SUPPLEMENTAL DESIGN INFORMATION

IHNC REMAINING LEVEES

WEST LEVEE VICINITY FRANCE ROAD AND FLORIDA AVENUE

LMVED-TD (NOD 22 Dec 69) 7th Ind
SUBJECT: Lake Pontchartrain, La. and Vicinity, Lake Pontchartrain Barrier
Plan, Design Memorandum No. 2, General - Supplement No. 8 -
IHNC Remaining Levees

NET PRESSURE DIAGRAM
STATION 223+73.08 TO 237+42.51
(ALONG FLORIDA AVENUE DRAINAGE CANAL)

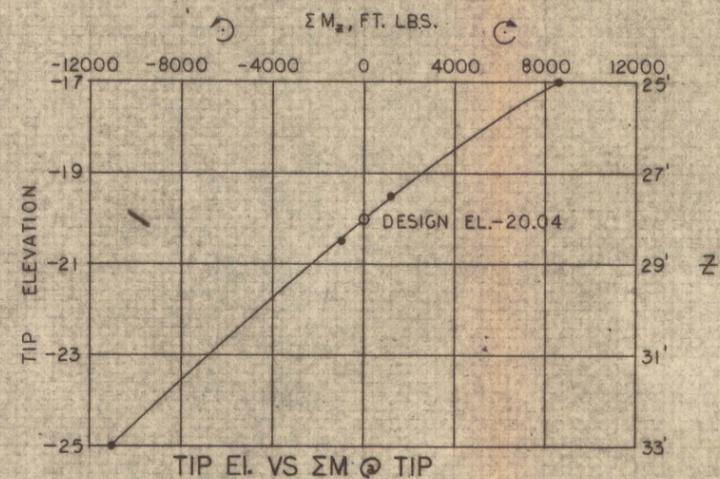
3. Plate 9. The relatively large design sheetpile penetration in this reach suggests that deflection of the wall could be excessive. To help limit such deflection, consideration should be given to constructing the levee in the reach along Florida Avenue Drainage Canal to el +9.0 instead of +8.0 as recommended, if this does not significantly complicate the overall stability of the levee and wall section. Based on the analysis shown on Plate 12, it does not appear that this would be a problem.

3. Para 4. We have no objection to extending the tip of the sheetpile to el -20.0 from sta 223+73.08 to sta 237+42.5 in order to cut off the organic clay layer as indicated. However, the sheetpile design presented on Plate 9 of the supplemental design information submitted with the basic letter indicates that the design tip elevation of the sheetpile in this reach is -20.04 to provide the design factor of safety of 1.50. This indicates that the pile tip elevation of -20.0 is required for stability, and not merely extended to this elevation to cut off the organic clay layer as is indicated. With this the case, the deflection of the wall in this reach would probably be approaching an excessive value, as we previously indicated in para 3, 1st Ind. In regard to the sheet pile design on the opposite side of the Florida Avenue Canal, it is not apparent which design is considered "nearly identical" to the design in question. If the reference is to the I-wall design for that portion of the protection south of and parallel to the Florida Avenue Canal, the two designs are not identical. The I-wall south of the canal is designed for a levee grade of +9.0 instead of +8.0 and has a design tip elevation of -8.5 in lieu of -20.0. The predicted deflection of the wall with the tip at el -8.5 would be much less than the wall with a tip at -20.0. In our comments on the I-wall designs in other areas of the protection south of Florida Avenue Canal, the possibility of excess deflection was pointed out for designs requiring pile tip elevations of -20 or lower. In view of the above, the reply to our comment in the 1st Ind is not considered adequate. The levee along the Florida Avenue Canal should be constructed to el +9.0 as was the levee on the south side of the canal to help limit deflections.

4. Par 3. The sheet piling from station 223+73.08 to station 237+42.51 extends to elevation -20.0 to cut off the organic clay layer from elevation -5.0 to elevation -17.0 (see plate 9). Being adjacent to the canal, this stratum presents a potential drainage path beneath the proposed levee if not cut off. Sheet pile design on the opposite side of the canal (refer to Lake Pontchartrain, La. and Vicinity, GDM No. 2, Advance Supplement, Inner Harbor Navigation Canal West Levee, Florida Avenue to IHNC Lock, approved 31 May 1967), which is nearly identical to this design, indicates that predicted deflection of the piling is not excessive.

NET PRESSURE DIAGRAM

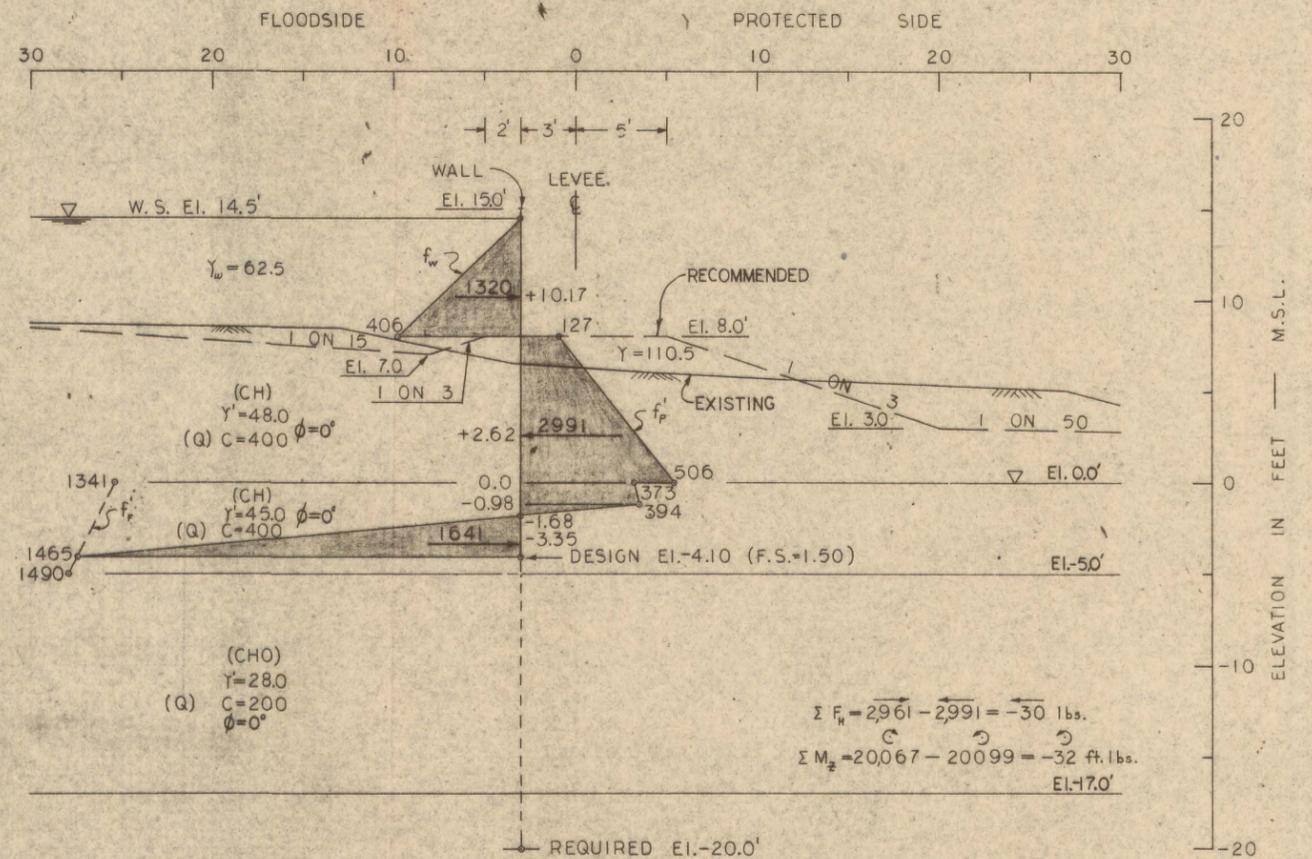
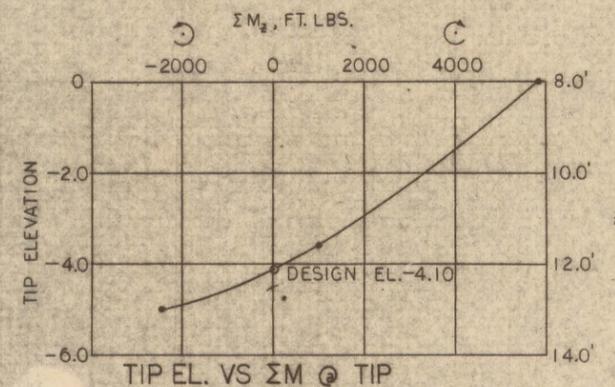
b. The section shown on Plate 10 from sta 223+73.08 to sta 237+42.51 indicates el 3 for the toe of the recommended levee on the protected side. Plates 12 and IV-36A indicate elevation 4.0 for the toe. This discrepancy should be resolved.

6. Par 4b. Plate 10 is in error. The toe elevation on the protected side should be 4.0 as shown on plates 4 and 12.

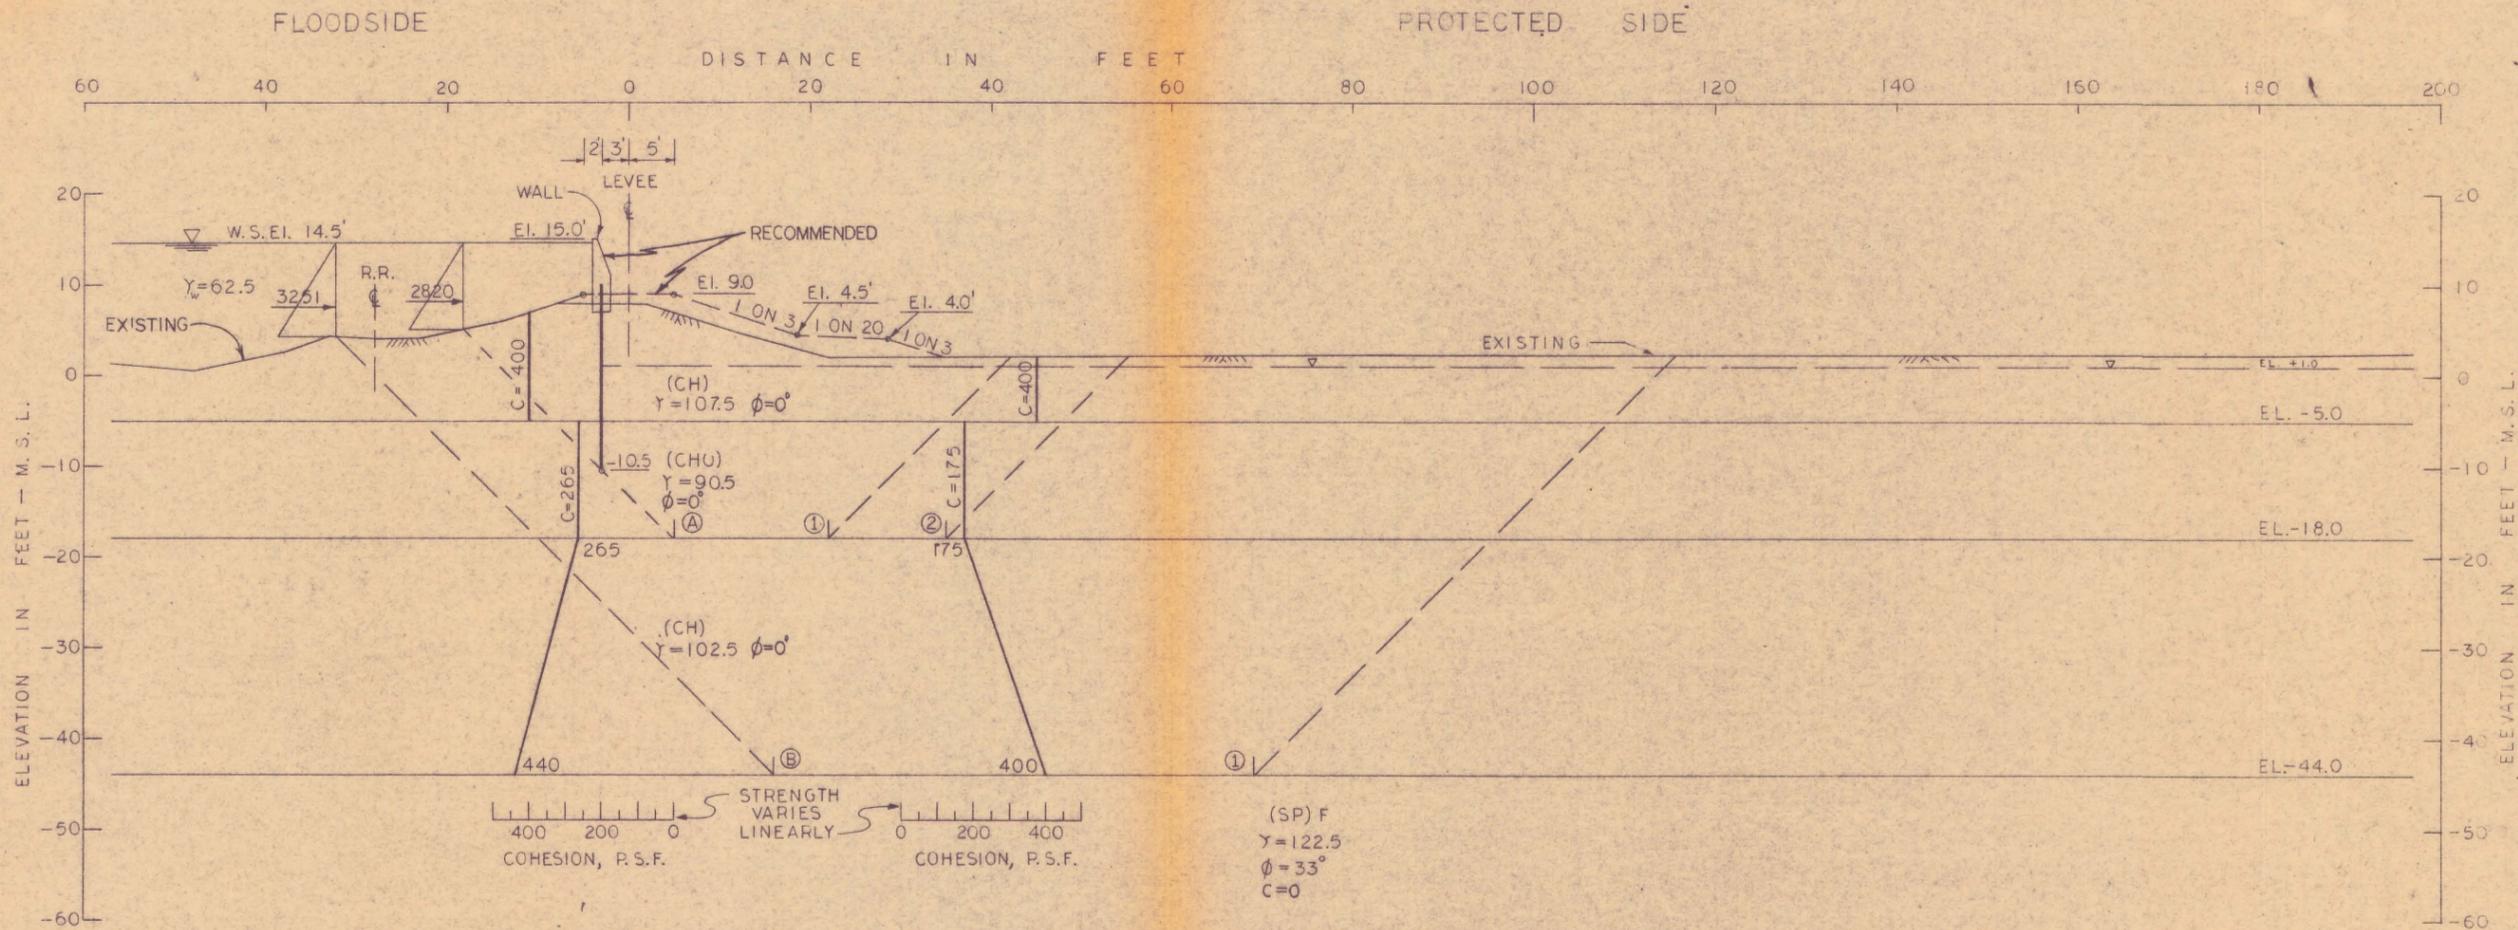
5. Plate 13. The piling arrangement shown on Plates IV-36A and IV-47 result in a wall which depends on the lateral resistance of the piling to resist the moment of resultant wall loads eccentric about the elastic center of the piling. The strata of weak soil indicated on Plate 13 may result in a very low lateral pile resistance. In fact the net load diagram for the "Q" case for Station 219+06.29 to 220+70.54 indicates that the earth rather than laterally supporting the piling may actually be supported by the sheet piling and bearing piling acting together. Such loading will tend to rotate the wall in a counterclockwise direction and may produce high bending stresses in the bearing piling. A pile arrangement in which the moment due to eccentric loads is resisted by axial pile loads may be desirable.

7. Par 5. Based on guidance from LMVD personnel, the net pressure diagram for the sheet pile cutoff was modified in accordance with the following procedure:

an additional lateral load to be carried by the bearing piles. Inclosure 3 is the modified sheet pile pressure diagram for this reach and indicates that there are no unbalanced forces acting on the sheet pile cutoff. Therefore, the pile arrangement originally submitted is adequate.

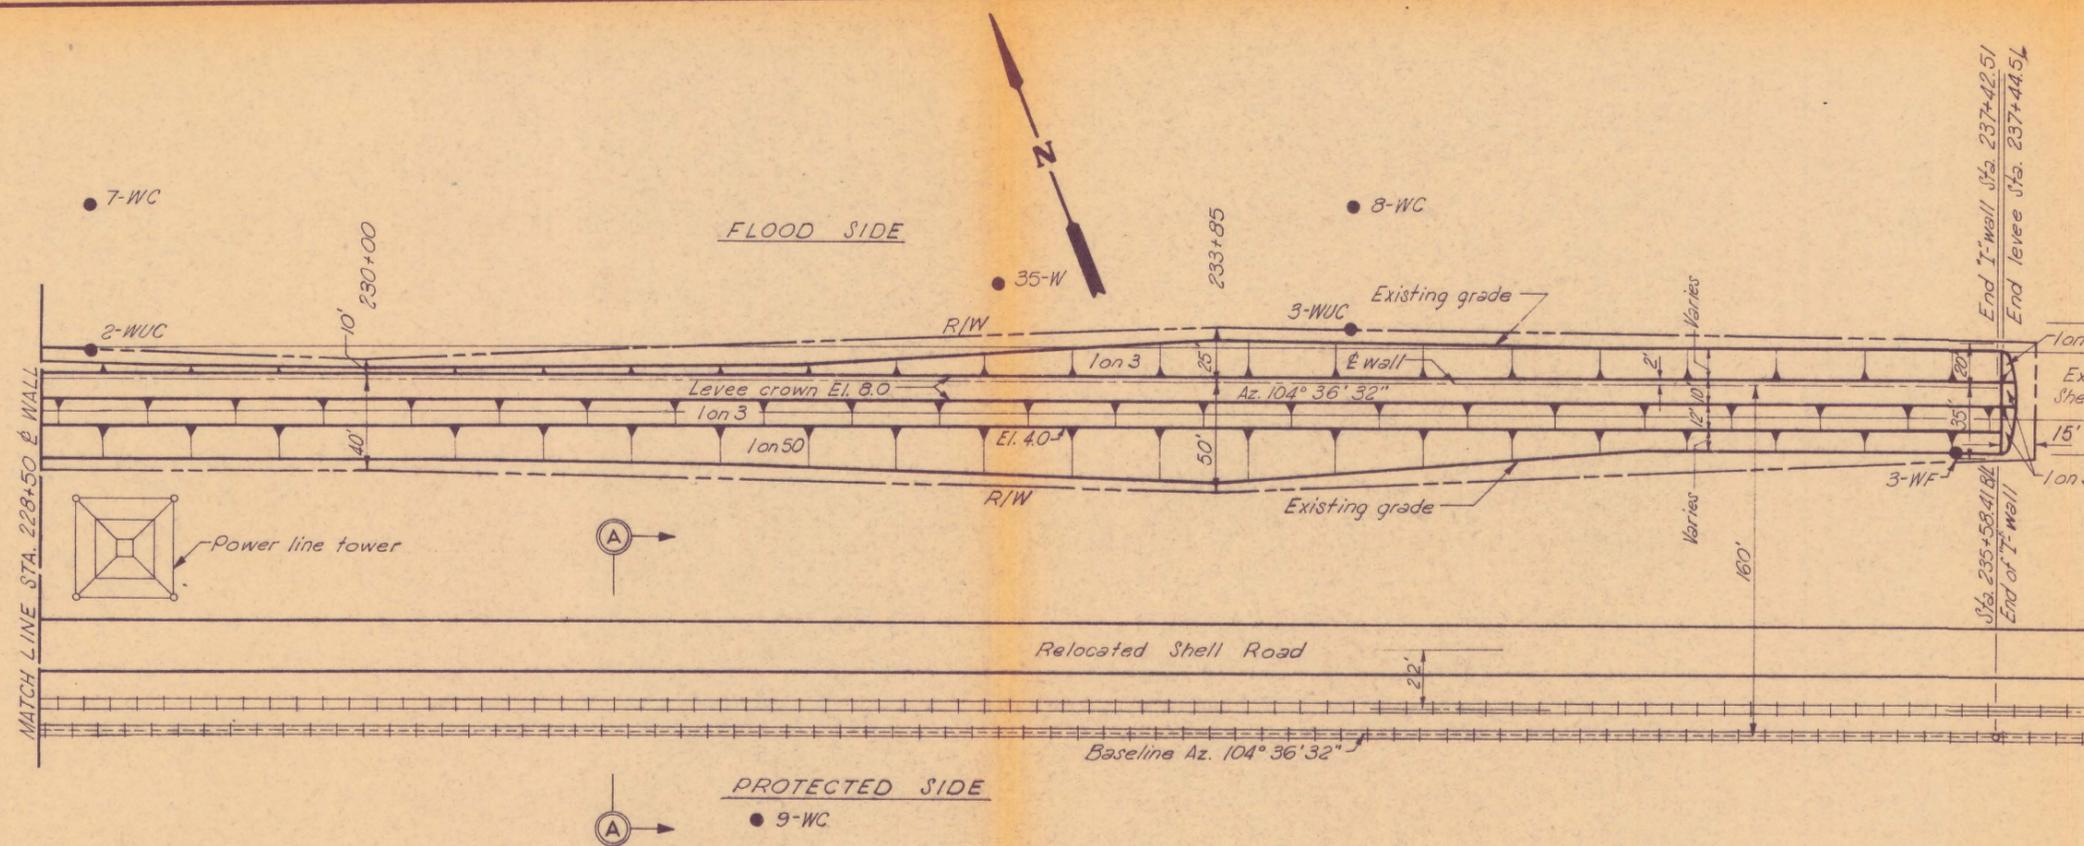
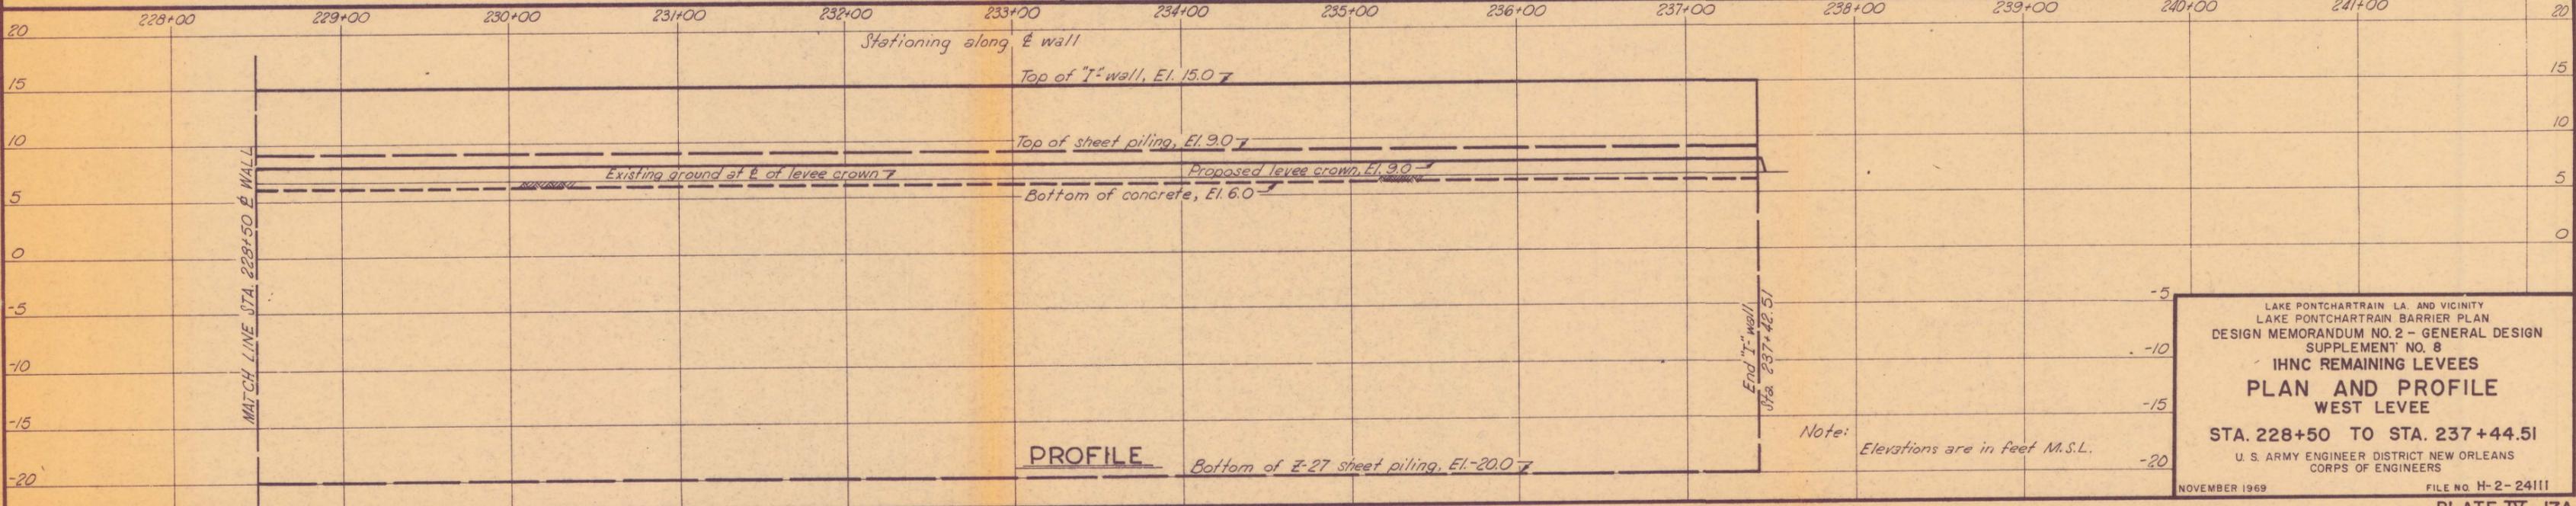
6. Plate IV-17A. The proposed levee crown elevation shown on the profile should be 8 instead of 9.

8. Par 6. Concur.

STA. 210+75 to STA. 219+06.29
Scale: 1" = 3'

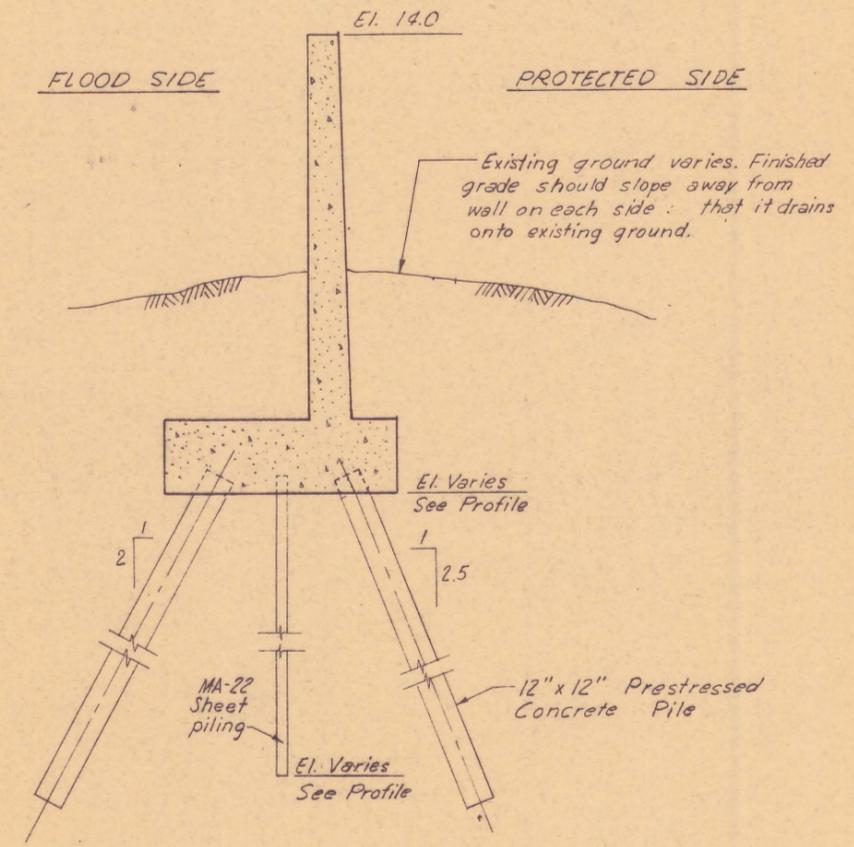
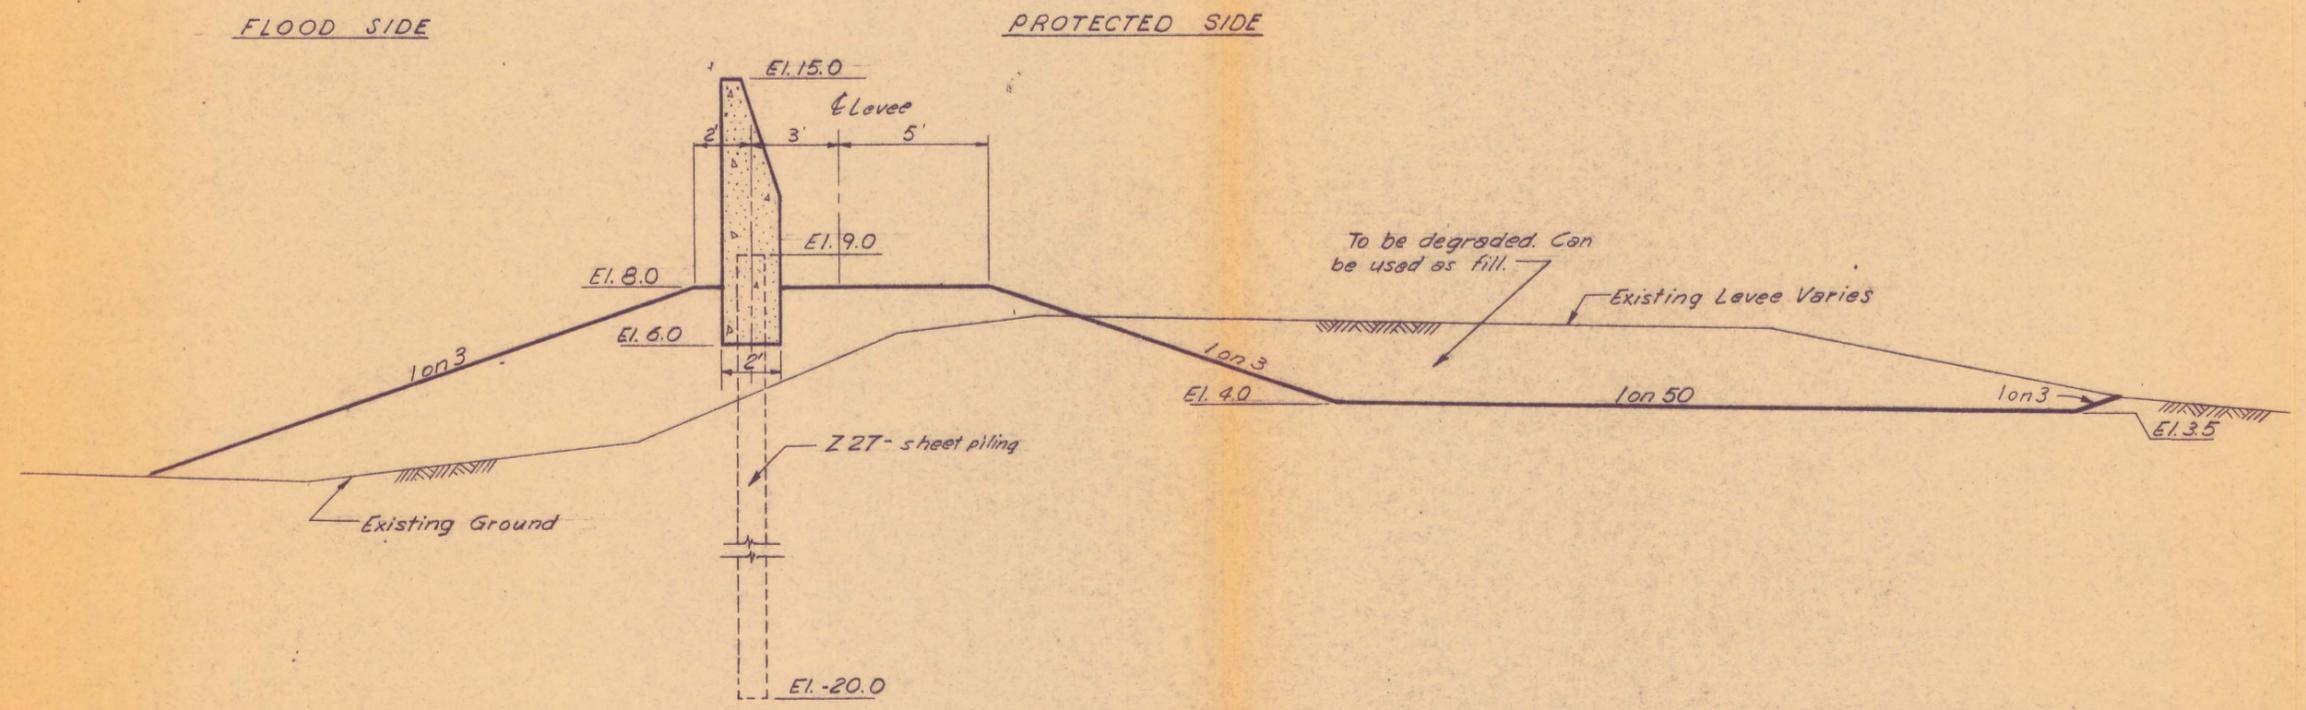
7. Plate IV-36A. The existing ground surface shown on the design section from sta 223+73.08 to sta 237+42.51 differs from that shown on Plates 10 and 12 for this reach. In the sections on Plates 10 and 12, the wall appears to be located at the south edge of the existing levee, whereas, on Plate IV-36A the wall is located on the north side of the existing levee. This apparent discrepancy in typical section should be clarified. If the section shown on Plate IV-36A between the above stations is typical, consider locating the new levee at and wall farther south to take better advantage of the existing levee.

9. Par 7. The existing levee runs parallel to and slightly north of the floodwall centerline from station 223+73 to approximately station 232+00. At station 232+00 it veers slightly to the south. The section shown on plate IV-36A was cut beyond station 232+00 and reflects the levee and an existing roadbed adjacent to the levee. The sections on plates 10 and 12 reflect ground conditions along the alignment west of station 232+00. The variation in cross sections through the area will be clearly illustrated on the contract plans by showing ground surface elevations on the plan view and plotted cross sections at 200-foot intervals.
